PARKSIDE TOWNHOMES
 RAMSEY, MINNESOTA
 LANDSCAPE LAYOUT PLAN
 FOR
COR AT RAMSEY LLC
 3313 LAKESHORE COURT, CHASKA, MN 55318

DRAWN BY	BH
DATE	01/17/2023
REVISIONS	
PROJECT NO.	22-164
	L1.1

Status as of 01/19/2023 08:14 AM

LANDSCAPE LAYOUT PLAN:

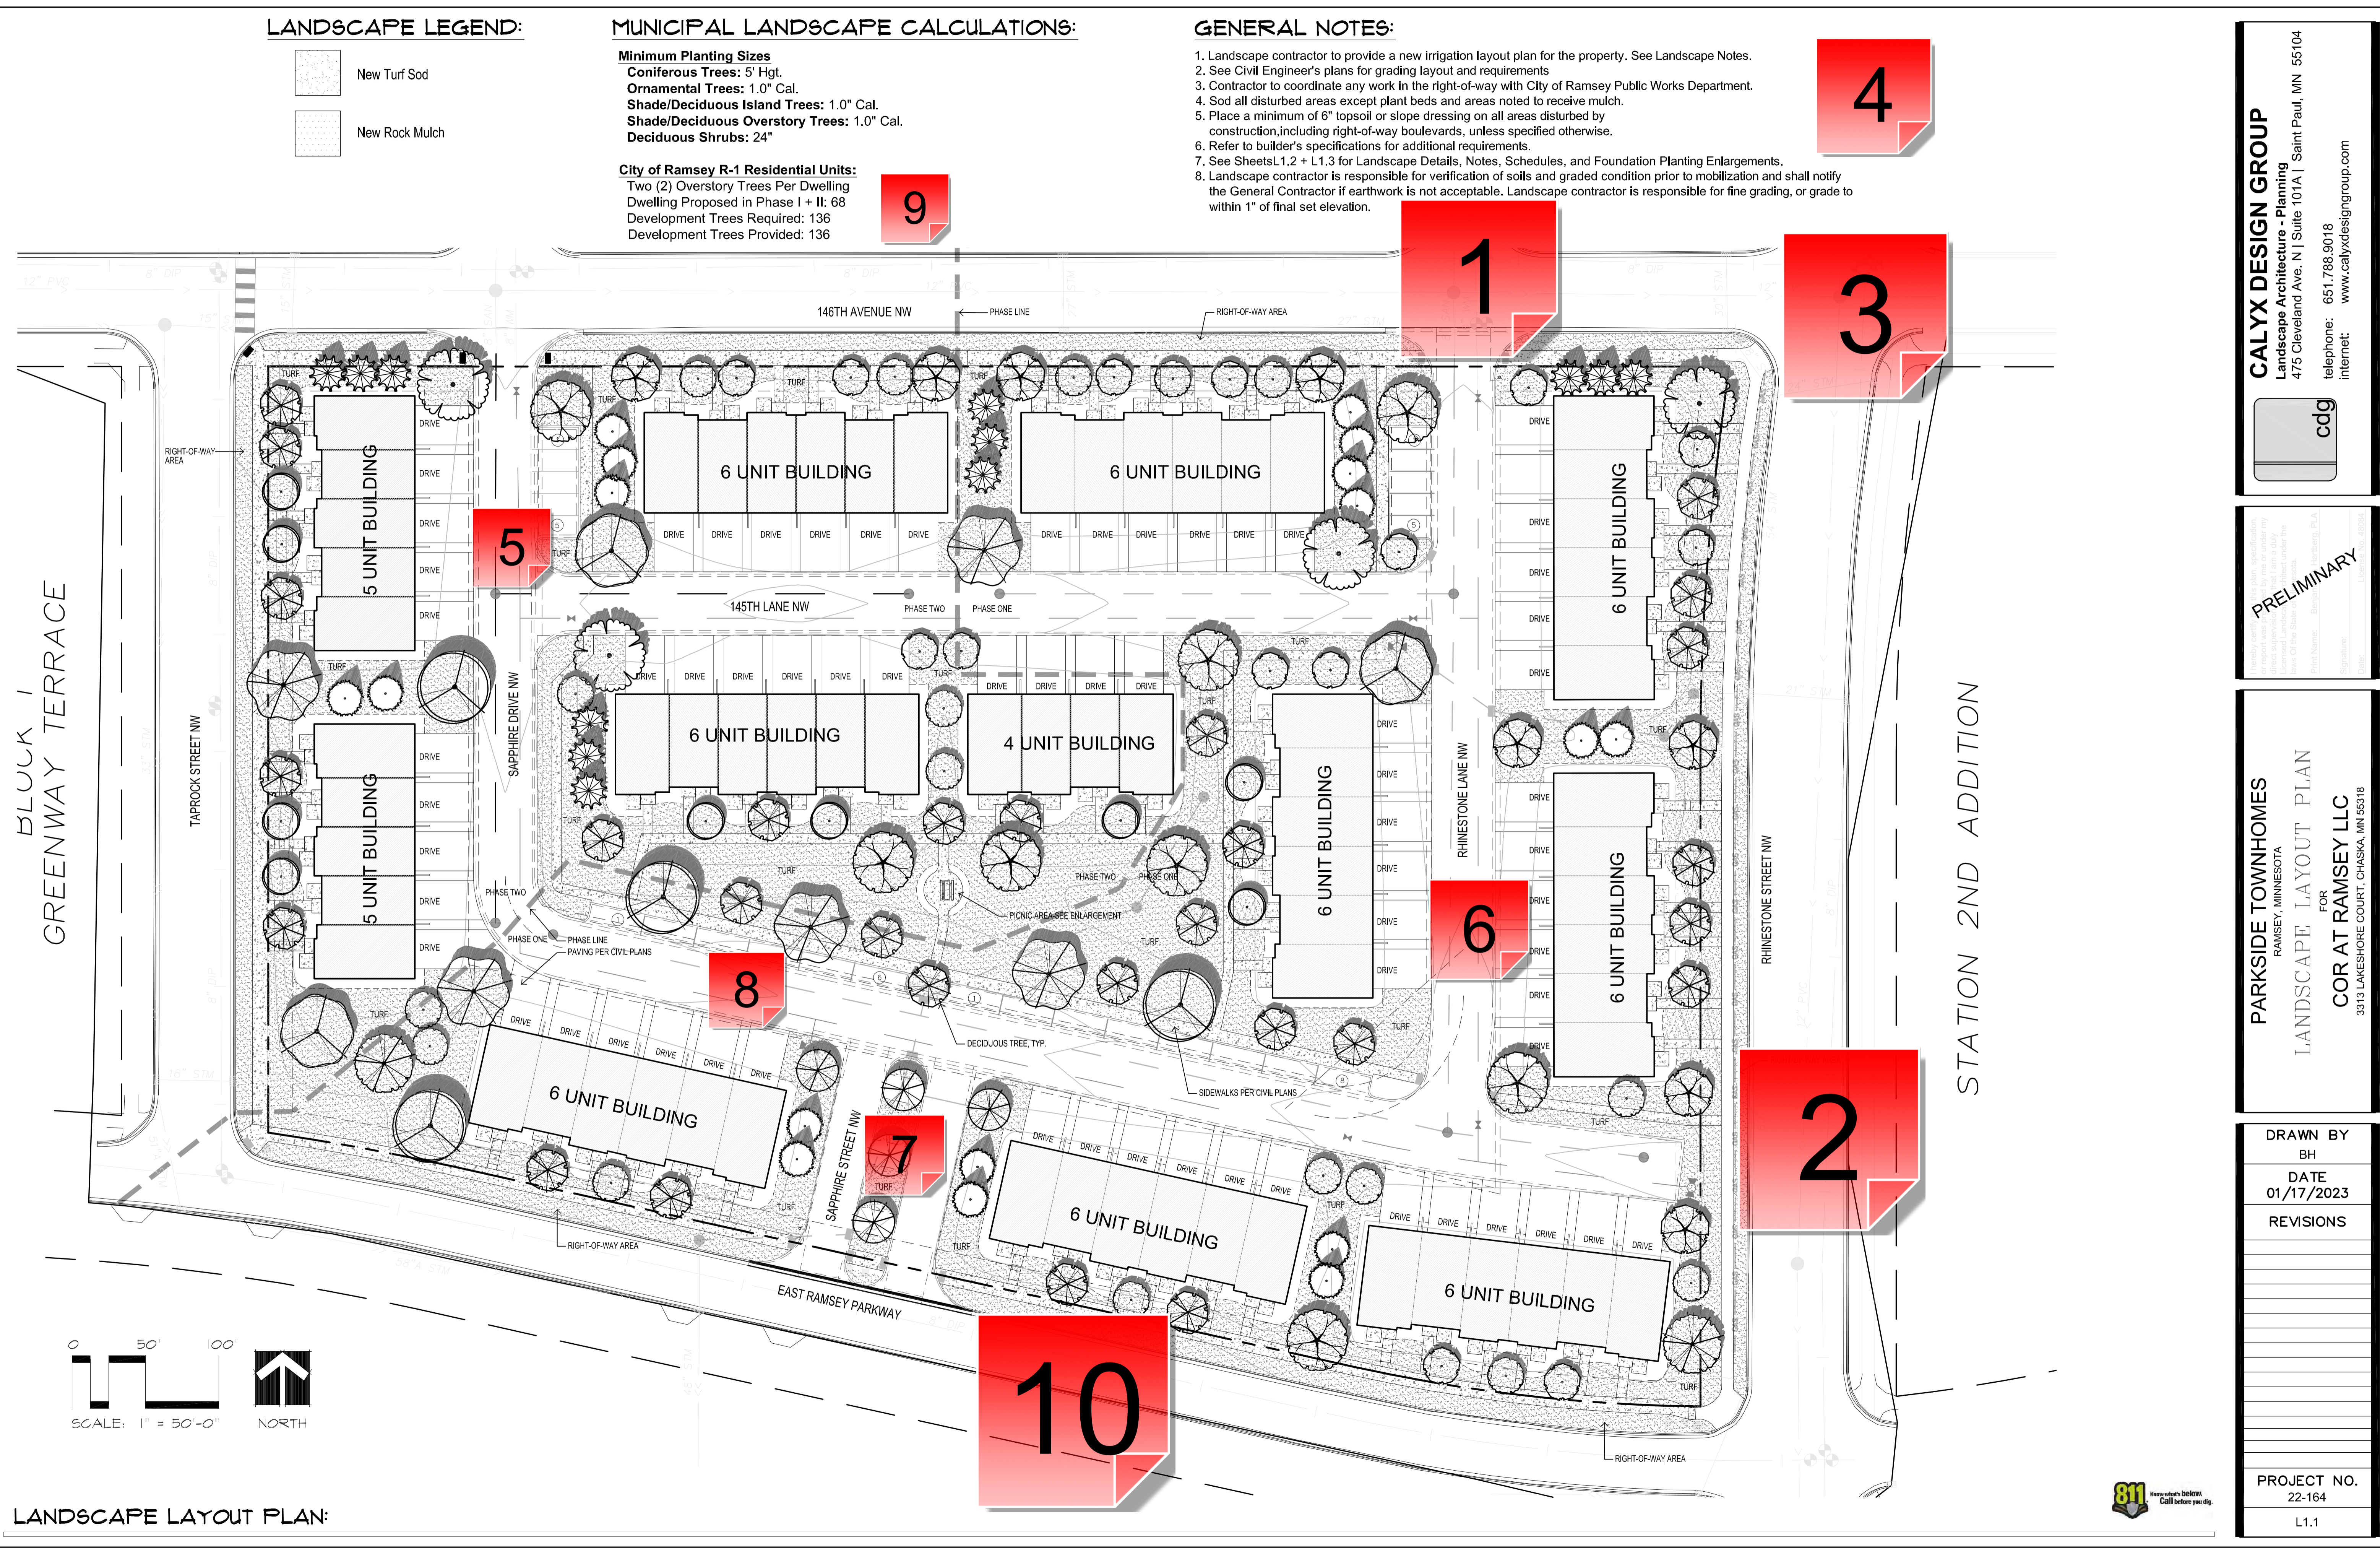
The COR District emphasizes an attractive streetscape, including boulevard trees and street furniture. Please review the street tree and street furniture sections of the COR Design Framework, beginning on page 83:
<https://www.ci.ramsey.mn.us/DocumentCenter/View/669/The-COR-Design-Framework-PDF?bidId=#page83>

Per the Street Hierarchy, Rhinestone Street is categorized as a Connector Street and Ramsey Parkway is categorized as a Parkway Street. The other 2 streets are categorized as Local Streets. This is needed to determine appropriate tree species in the boulevards.

Blvd trees shall be spaced at 35 feet on center.

Add (or modify existing) note that all disturbed areas not otherwise improved with impervious surfacing shall have four (4) inches of topsoil, with not more than 35% sand content. Topsoil inspection is required PRIOR to installing sod and trees.

Update Street name to Sapphire Way.

Update Street name to Rhinestone Terrace NW

Update Street name to Sapphire Lane NW.

Add street name of 145th Place NW.

The R-1 planting standards are not applicable to this project. This project is more similar to R-3, you can refer to those standards here:

Per the Design Framework, street furniture, such as bike racks, trash receptacles, and benches are required along Parkway streets. City Staff would suggest that these be installed on the south side of Ramsey Parkway, adjacent to The Draw park, rather than in front of the 3, 6-unit buildings. Please coordinate with City Staff as there are specific models of each of the furniture sites that are acceptable.

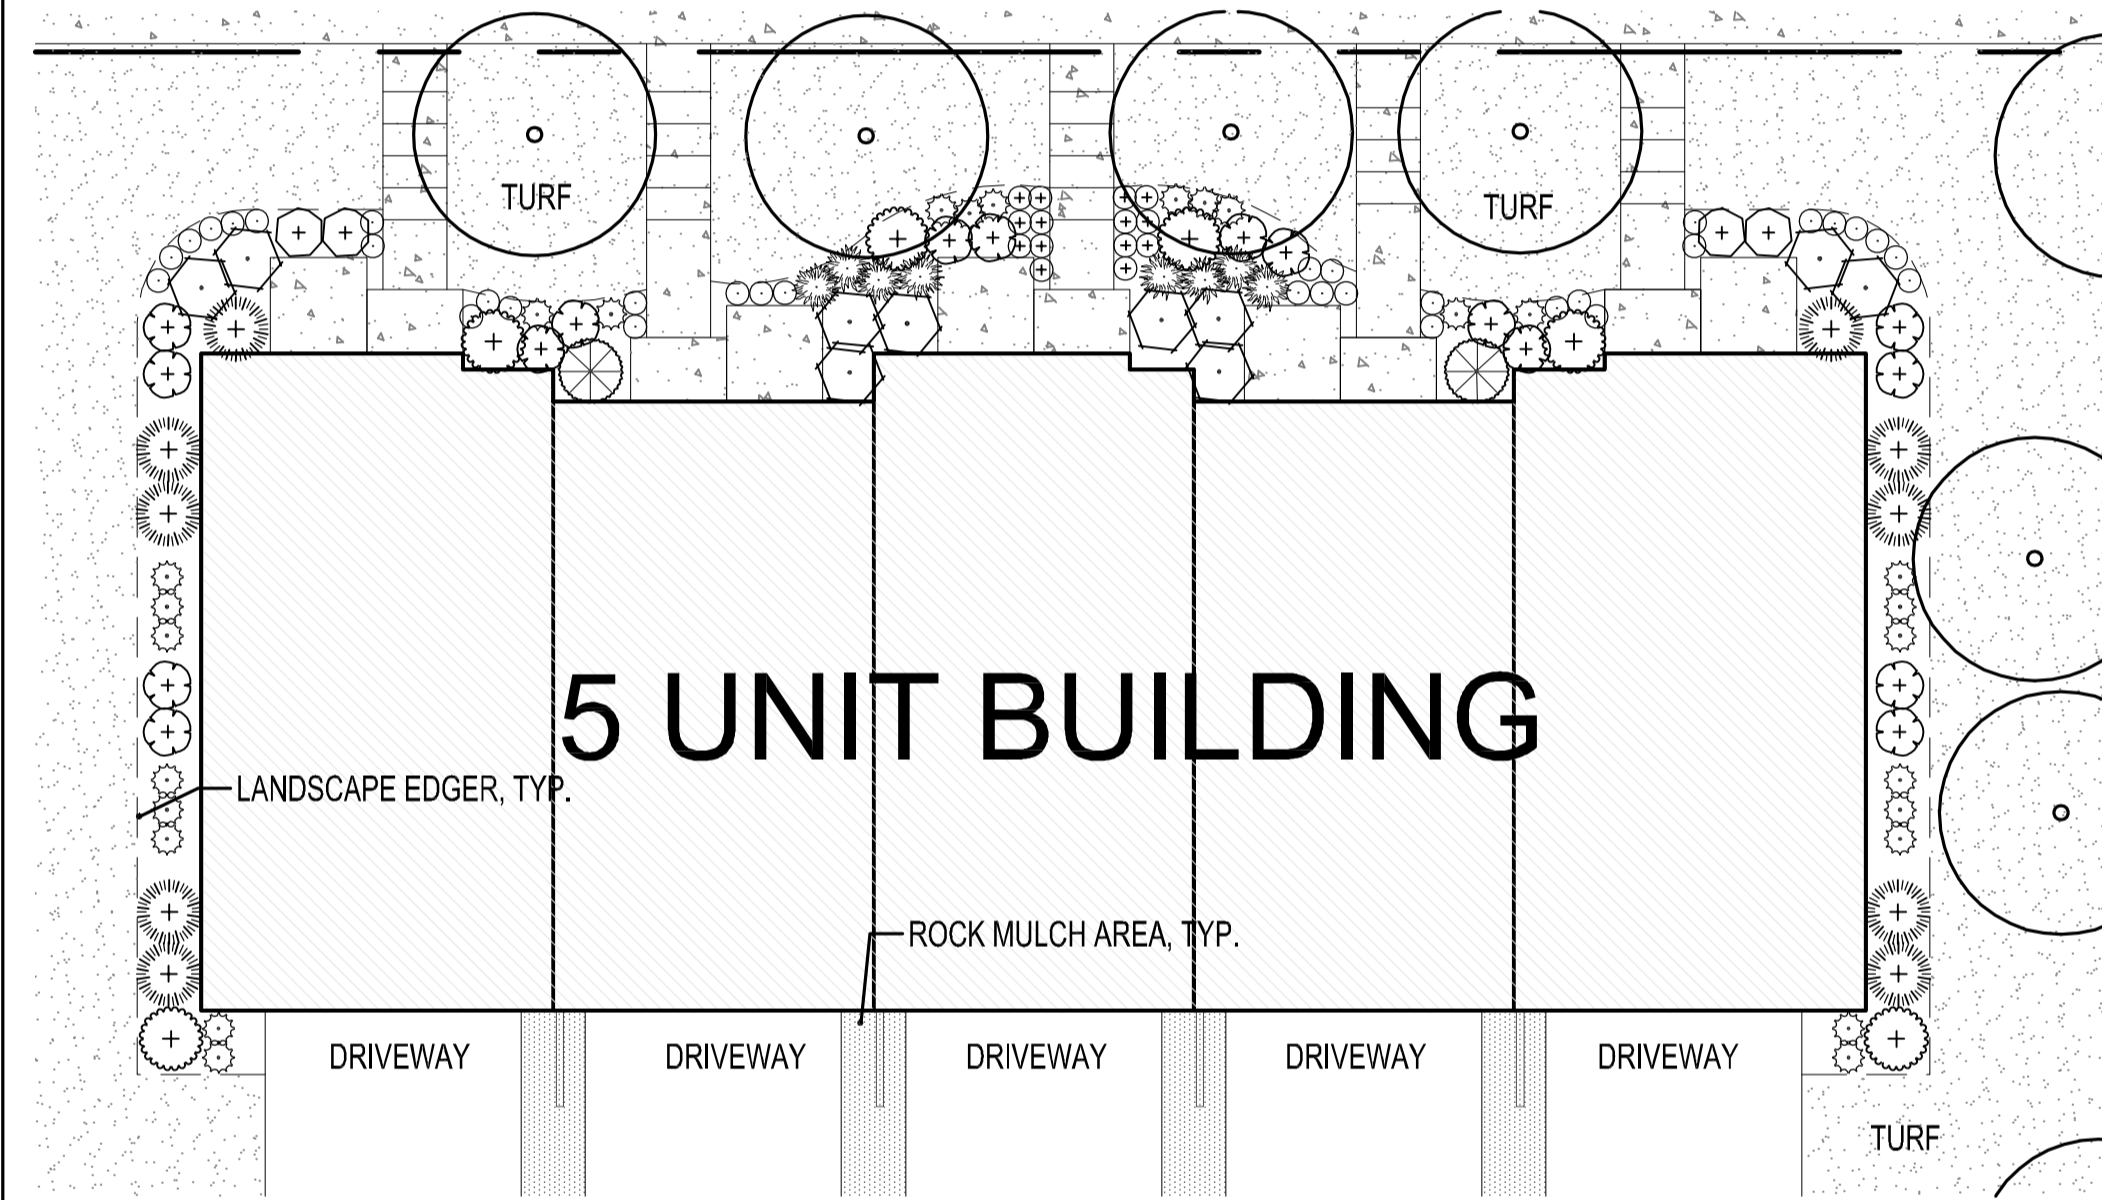
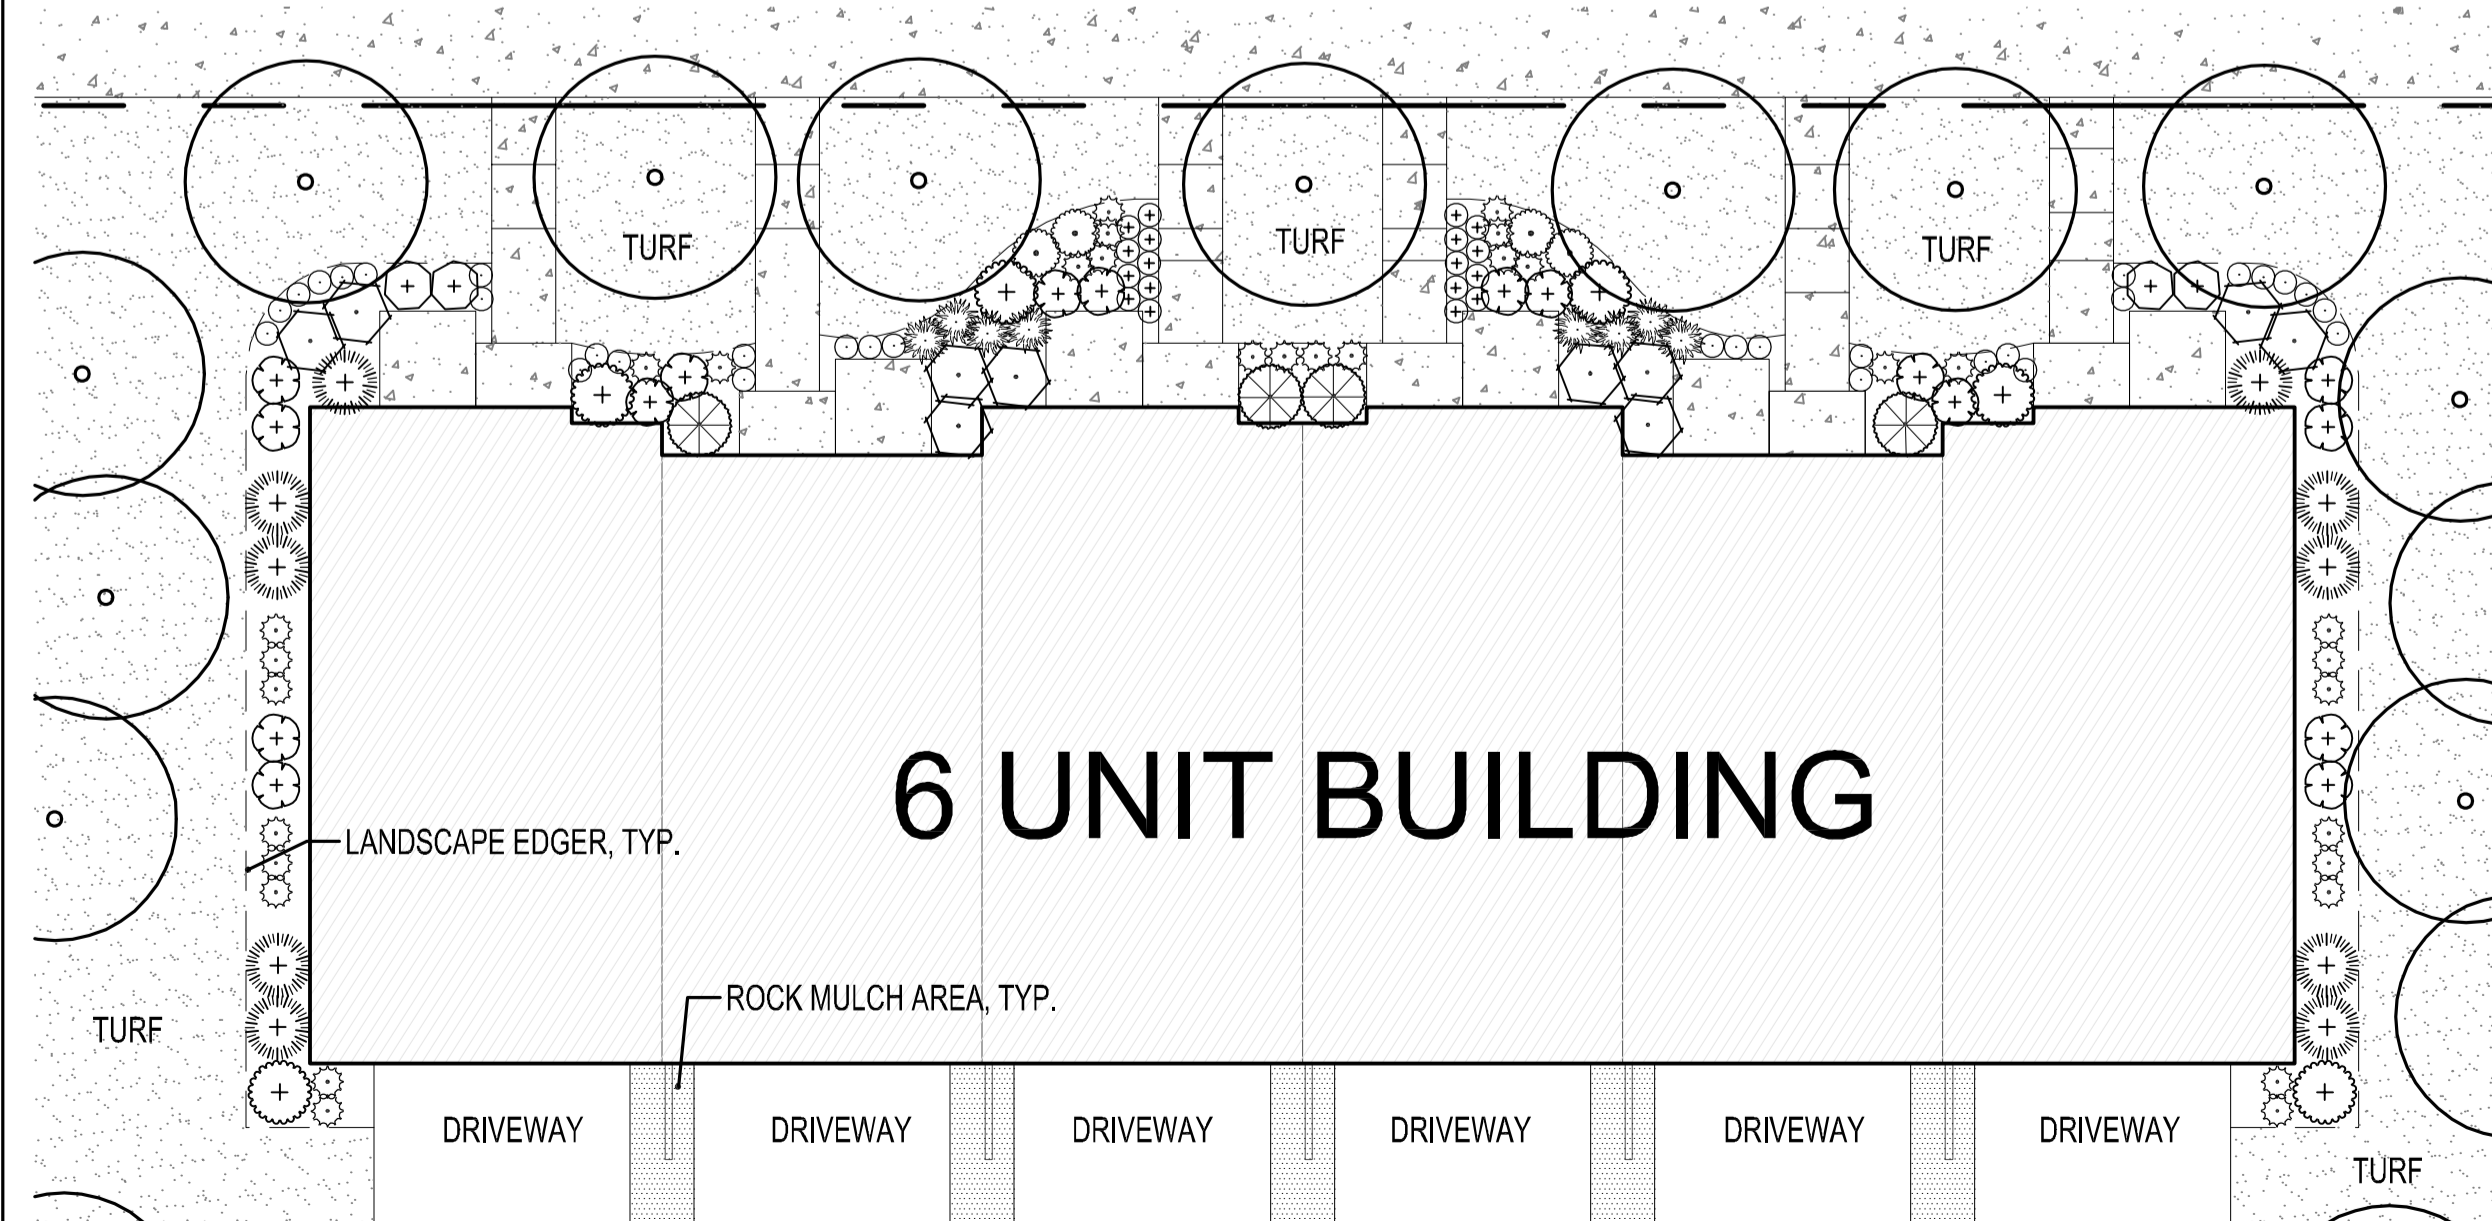
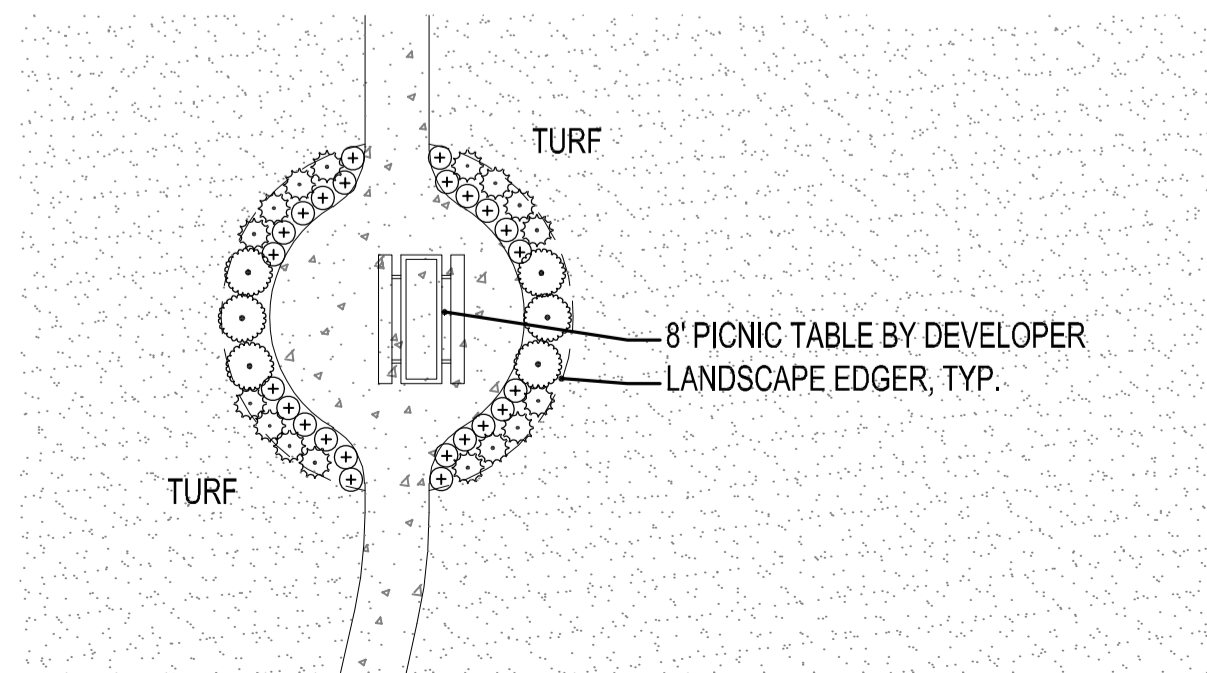
City Code requires a minimum of four (4) inches of topsoil applied to all disturbed areas not otherwise improved with impervious surfacing. Topsoil shall consist of not more than 35% sand content.

Modify Planting Schedule to specify that minimum size of shrubs at installation is 24 inches in height.
